**AQUATIC EFFECTS MONITORING PROGRAM ANNUAL 2018
REPORT – PLAIN LANGUAGE BRIEFING AND TECHNICAL
REVIEW COMMENTS**

Technical Memorandum # 367-19-02

Environmental Monitoring Advisory Board (EMAB)
P.O. Box 2577
Yellowknife, NT
X1A 2P9

May 23, 2019

Figure 3-5. Biomass of Major Zooplankton Groups in Lac de Gras, 2018 (from Golder 2019).

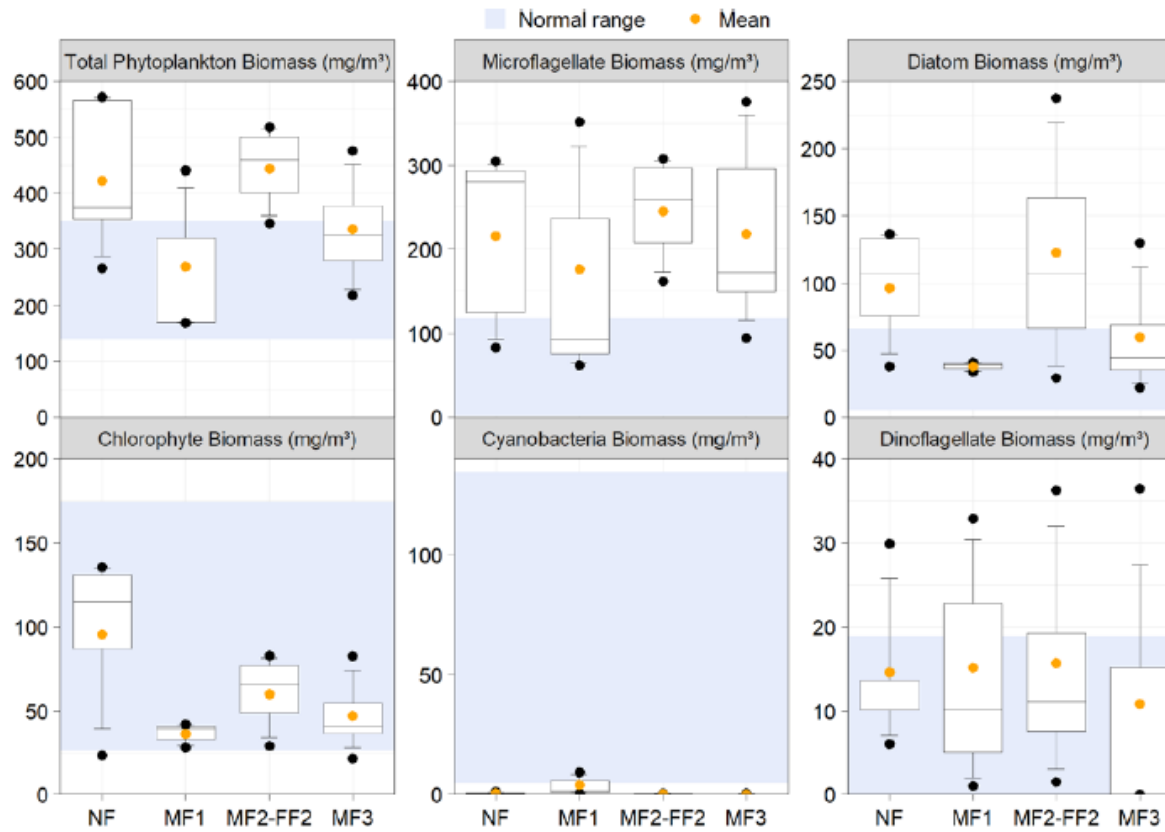
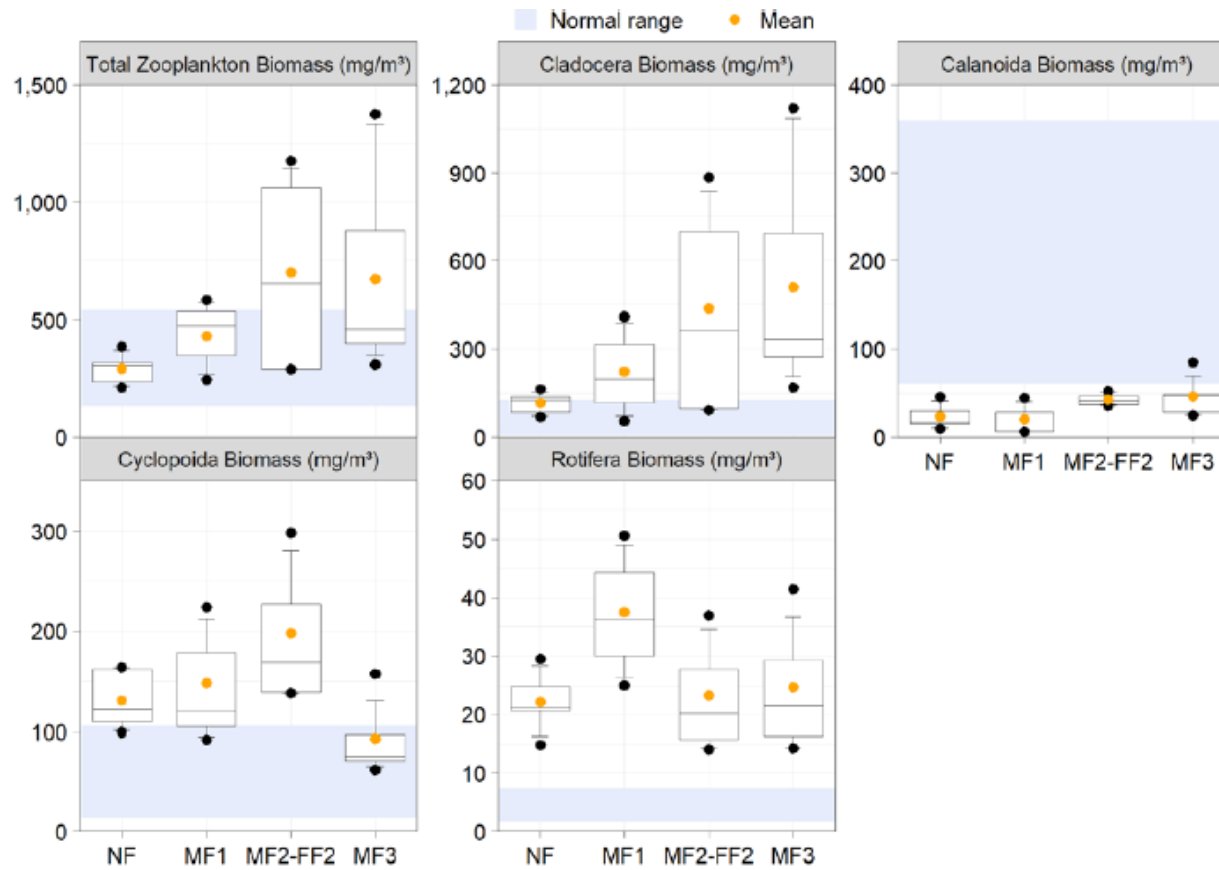
The patterns of phytoplankton and zooplankton biomass presented in Appendix XI differ. Specifically, total zooplankton biomass presented in Figure 3-5 (page 19) shows an increasing trend from the NF to the MF areas; this trend was even more pronounced for cladoceran biomass. Conversely, phytoplankton biomass as presented in Figure 3-2 (page 13), shows relatively similar densities across the four areas. Can Diavik comment on potential reasons for the observed differences?

Recommendation: Provide a discussion and interpretation of the phytoplankton and zooplankton results collectively.

Figure 3-8. Concentrations of Total Phosphorus in Lac de Gras in Relation to Dust Deposition during the Open-water Season, 2018 (after Golder 2019).

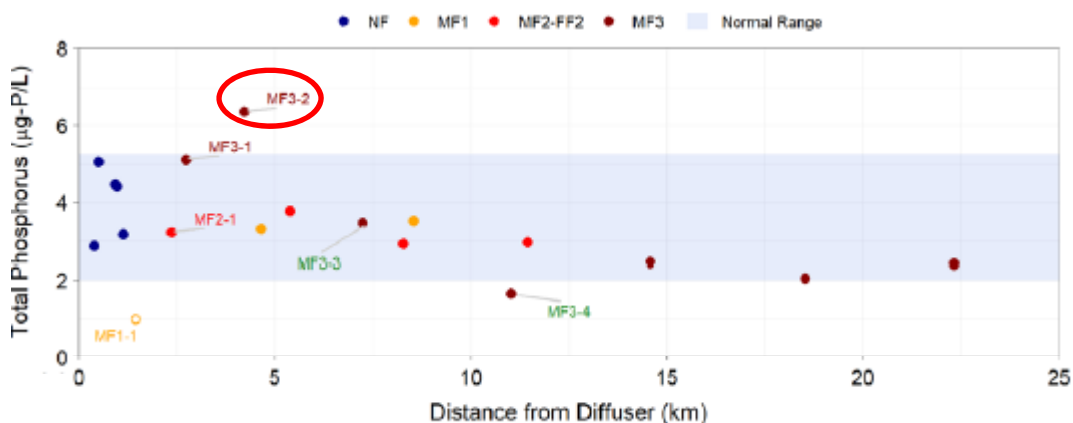
The report concludes that: "Overall, TP concentrations in the NF and MF areas were consistent with the Mine effluent being a greater source of TP input to the lake than dust" (Appendix XIII, Section 3.2, page 26). However, Figure 3-8 (page 27) indicates the highest concentration of TP occurred at site MF3-2 (see red circle below), which would suggest that dust was a significant source of TP to the lake. The highest concentration of TP and TSS measured in snow occurred at site SS3-8 and the nearby Dust 7 site had relatively high levels of dust; these sites are near site MF3-2.

Recommendation: Review and revise text in relation to dust effects on TP.

Figure 3-12. Concentrations of Total Nitrogen and Total Dissolved Nitrogen in Lac de Gras during the Ice-Cover and Open-Water Seasons, 2018 (after Golder 2019).

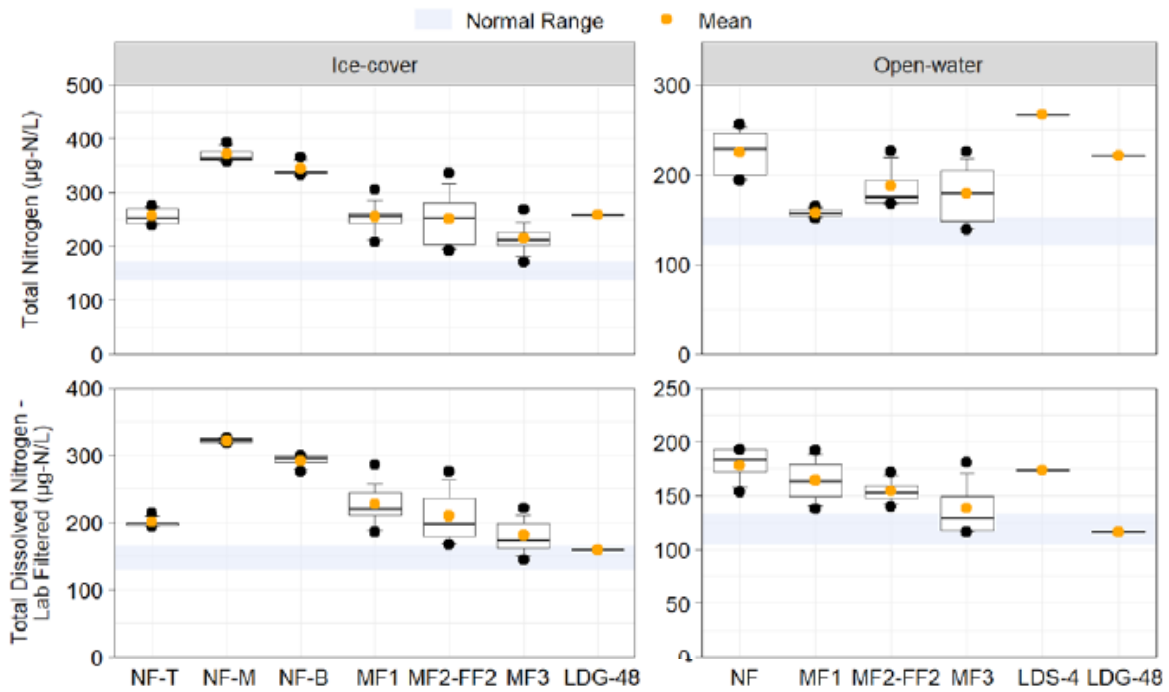
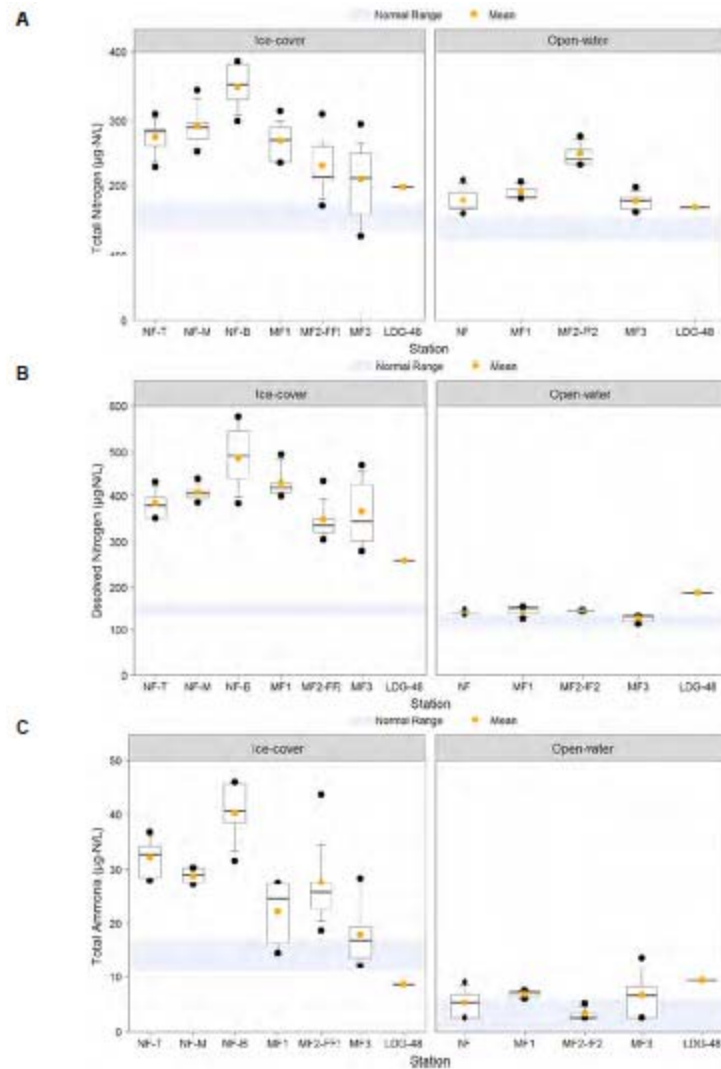
Figure 3-12 (Appendix XIII, page 33) does not support these statements. Therefore the results from 2017 remain an anomaly (i.e., 2018 results did not resemble the 2017 results). Figures from the 2018 and 2017 AEMP reports are presented below for reference.

DDMI committed to "evaluating TDN concentrations at LDG-48 in 2018 to determine in the 2017 value is typical (WLWB comment 22)" (Table A-1 Main Report). Given that 2017 is not "typical" relative to 2018 results, some discussion should be provided in the text on the 2017 data.

Recommendation: Please review text and figures and revise accordingly and address the DDMI commitment.

Figure 3-16. Total Zooplankton Biomass (as AFDM) in Lac de Gras during the Open-Water Season, 2018 (from Golder 2018; Appendix XIII).

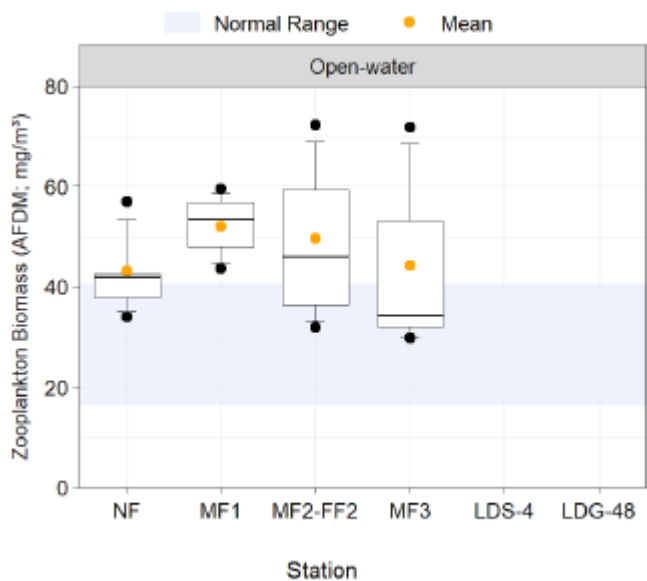
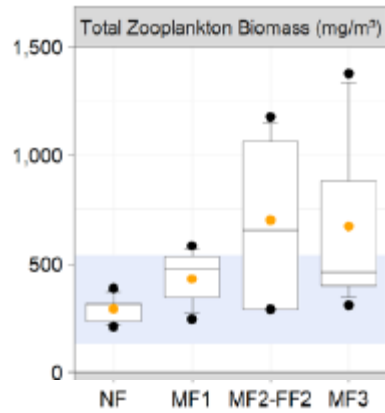
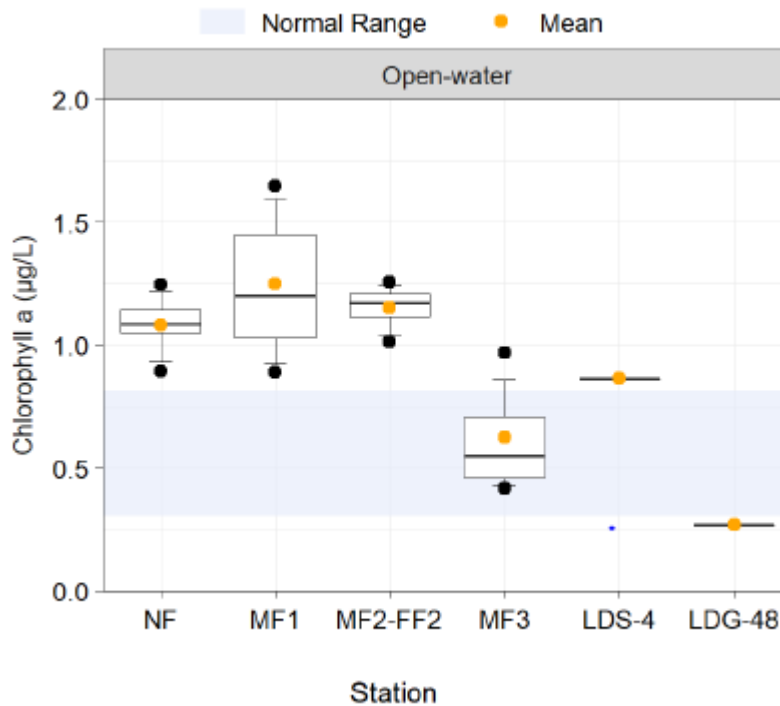
Zooplankton biomass measured as ash-free dry mass (AFDM; Appendix XIII, Figure 3-16, page 38) differed from biomass measured through the taxonomic enumeration and identification method (as presented in Appendix XI, Figure 3-5, page 19). Specifically, the indicator used for the eutrophication report (AFDM) shows that biomass was above the normal range in the NF MF1, and MF2-FF2 areas and that "no significant decreasing trends with distance from the diffuser were observed in zooplankton biomass along any of the three transects in 2018" (page 51), whereas the indicator presented in the Plankton Report shows total biomass was within the

normal range in the NF and MF1 areas and a "clear pattern of increasing total zooplankton biomass with increasing distance from the effluent discharge." (Appendix XI, page 17).

In addition, phytoplankton biomass and chlorophyll *a* measurements do not show strong agreement (see excised Figures 3-14 and 3-14 below). Lastly, the increasing spatial trend in zooplankton biomass is not reflected in the chlorophyll *a* or phytoplankton biomass data. A disconnect between the zooplankton and phytoplankton biomass may reflect lags in community responses. Alternatively, these differences may reflect analytical error.

Given the discrepancies, it would be beneficial to incorporate both measures of zooplankton biomass into the discussion for the eutrophication report, as well as incorporate phytoplankton biomass into the overall discussion and interpretation of results provided in Section 4.2, Appendix XIII.

Recommendation: Include both measures of zooplankton biomass and phytoplankton biomass into the overall discussion and interpretation of results collectively
